Appendix 1: The Government of Yukon's comments on
the Coastal Plain Oil and Gas Leasing Program Draft
Environmental Impact Statement

Provided below are comments as well as technical and scientific evidence compiled by the Government of Yukon in response to the Coastal Plain Oil and Gas Leasing Program draft Environmental Impact Statement (draft EIS) that the Bureau of Land Management is undertaking to implement the leasing program pursuant to the Tax Act (Public Law 115-97, Dec. 22, 2017).

Figure 3 – Porcupine caribou calving varies annually as a result of changing snow conditions on the Coastal Plain. Here we provide 4 examples of years when Porcupine caribou calved further west than the “primary calving habitat area”. In several cases this includes the core calving area used by

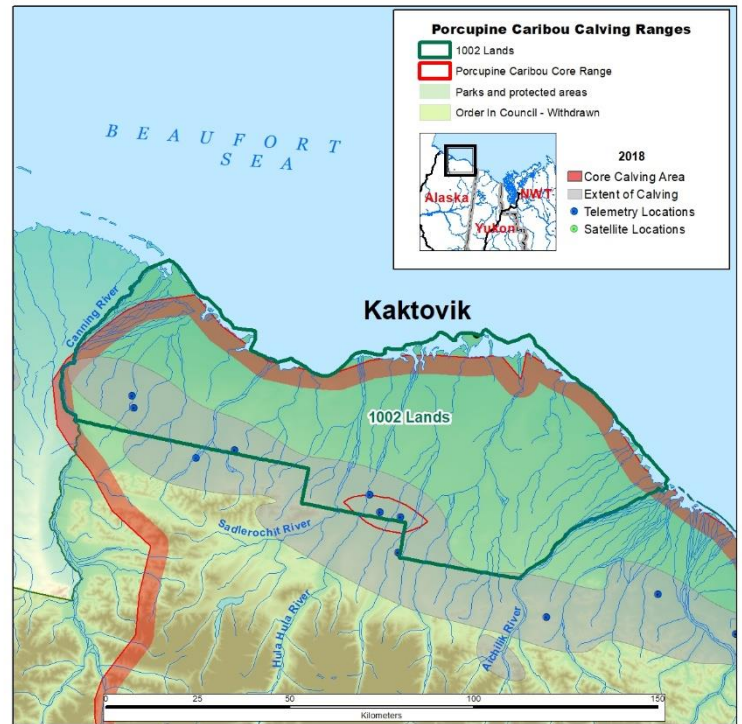
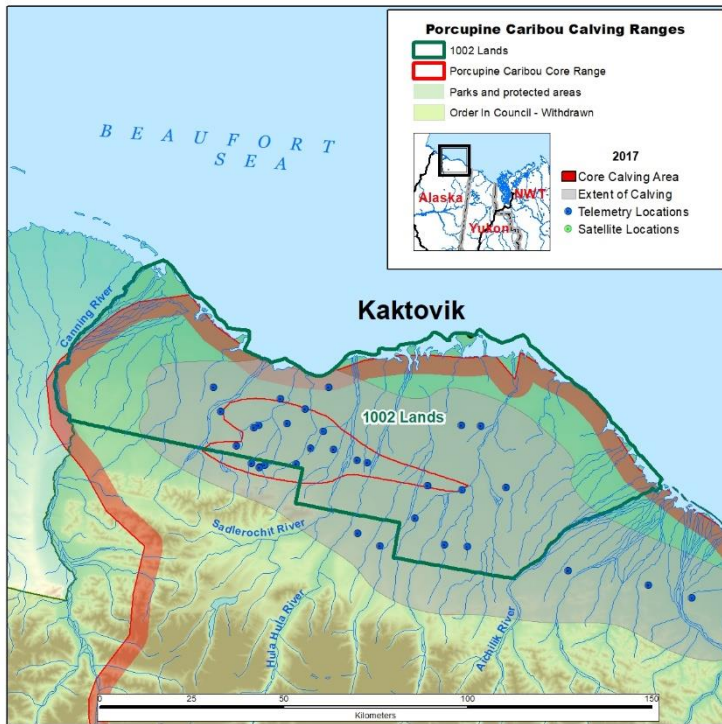
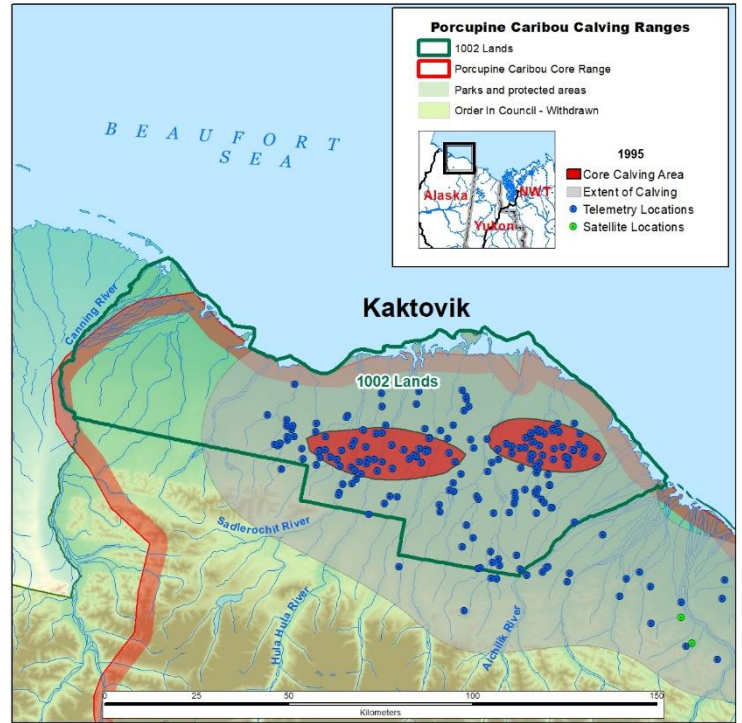
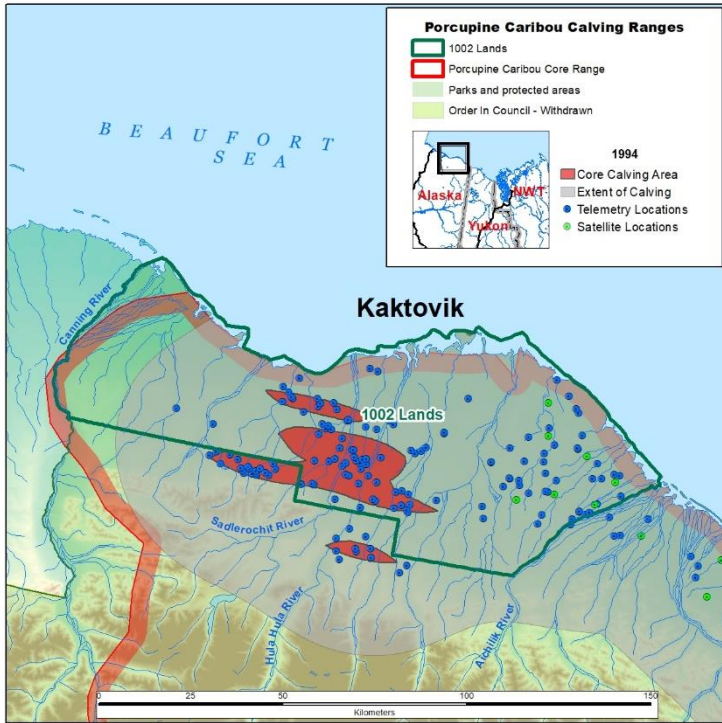
As a result of applying the general definition of a concentrated calving area, a second error appears in the interpretation and use of the shared data. Lease Stipulation 7 uses a polygon to describe the herd’s primary calving habitat area, and relies on calving as a static spatial event. In the absence of other considerations, calving may be completely exposed to full development pressures as substantial inter-annual variation can occur (see Figure 3) as result of varying weather patterns driven by climatic cycles such as the Pacific and Arctic Decadal Oscillations (Griffith et al. 2002, Joly et al. 2011). Not only do weather conditions impact the distribution of the herd during spring migration and calving, but weather conditions can also have significant effects on demographic parameters for the

Selecting areas that are most frequently used by caribou for calving for protective actions is important. However, the current description of calving area in the draft EIS fails to capture calving that occurs west and north of the identified “calving area” (although this is recognized in Section 3, page 107). Spatially we can see in Figure 3 caribou calve in high densities west of the defined “calving area” including just east of the Canning River. In subsequent years, if calving occurs in these areas and Alternatives B, C, or D1 are chosen, calving caribou would be afforded no specific protective measures, but rather standard terms and conditions.

There is a need to identify protective measures throughout the proposed development as calving is not spatially or temporally static and may occur anywhere in the proposed leasing areas. In fact, the draft EIS identifies that with anticipated climate change patterns in the area, an increased frequency of calving can be anticipated in the future in the proposed leasing area (see Section 3, page 110). Alternatives do not consider this important aspect of PCH calving, nor do they provide any supporting information. A simple 40 percent contour of years is used without supporting data or analyses. This fact is acknowledged briefly in the draft EIS (see Section 3, page 107) when referencing a US Fish and Wildlife Service report (2015); however, this comment is the only acknowledgement of this important factor and the Alternatives do not seem to reflect these important aspects of calving ecology.

Lastly, the selection of the 40 percent of years contour to define the area that Lease Stipulation 7 applies to appears to be arbitrary (see draft EIS, Section 3, page 114). The basis of most caribou mitigations include Alternative D. No leasing and no surface occupancy are chosen based on the “primary calving habitat area”. In particular, the use of no leasing areas is solely based on this parameter. However, an area that on average is used every third year (i.e., the 33 percent of years contour) is almost as important as one used on average every 2.5 years (i.e., 40 percent of years contour). The draft EIS selection of the 40 percent of years vs the 33 percent of years contour is not explained. It is unclear if the selection of the 40

the herd in that specific year. Under Lease Stipulation 7, these caribou would have had no specific protections.
